# INNER WEST COUNCIL

## DEVELOPMENT ASSESSMENT REPORT

<b>Application No.</b>	DAREV/2016/21
<b>Address</b>	95 Rowntree Street, BIRCHGROVE NSW 2041
<b>Proposal</b>	Review of Refusal Determination of D/2016/245 for alterations and additions to existing dwelling including ground and first floor additions and ground floor deck. Review entails amended plans.
<b>Date of Receipt</b>	21 November 2016
<b>Applicant</b>	Mr L Quach
<b>Owner</b>	Mr L Quach and Mrs J J Chan
<b>Number of Submissions</b>	2
<b>Building Classification</b>	Class 1a
<b>Reason for determination at Planning Panel</b>	Previously determined by Panel as a Discretionary Referral
<b>Main Issues</b>	Heritage Impacts; Scale: Privacy
<b>Recommendation</b>	Deferred Commencement Consent
<b>Attachment A</b>	Recommended conditions of consent
<b>Attachment B</b>	Plans of proposed development

Appendix B Figure of LDCP2013: Single storey terrace design approach

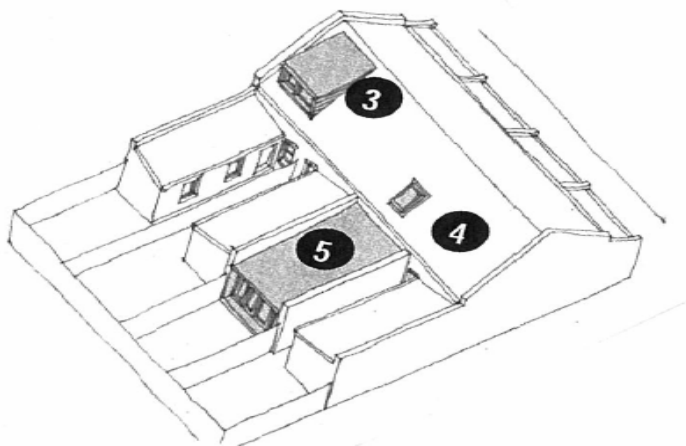
With respect to the rear first floor additions it was recommended that the works should adopt the controls in Appendix B of the LDCP2013 – *Building Typologies* for skillion dormers for single storey terraces identified in Figure 15 in Section 6.1 (see below), when designing the parent’s retreat. This would involve cutting back the length of the first floor parent’s retreat so that its rear wall and / or deck (if a deck was pursued) is behind the rear gutter line of the main dwelling form or a minimum of 200mm inside the rear wall plate of the original cottage, this design change is best depicted as Point 3 on the below Building Typology extract.

The modified design submission has repositioned the southern wall of the Parents Retreat to align with the rear wall of the neighbouring property first floor, being No.97 Rowntree Street, and this has co-incidentally also aligned the wall 200mm behind the original cottage rear wall plate, thus complying with the requirement above.
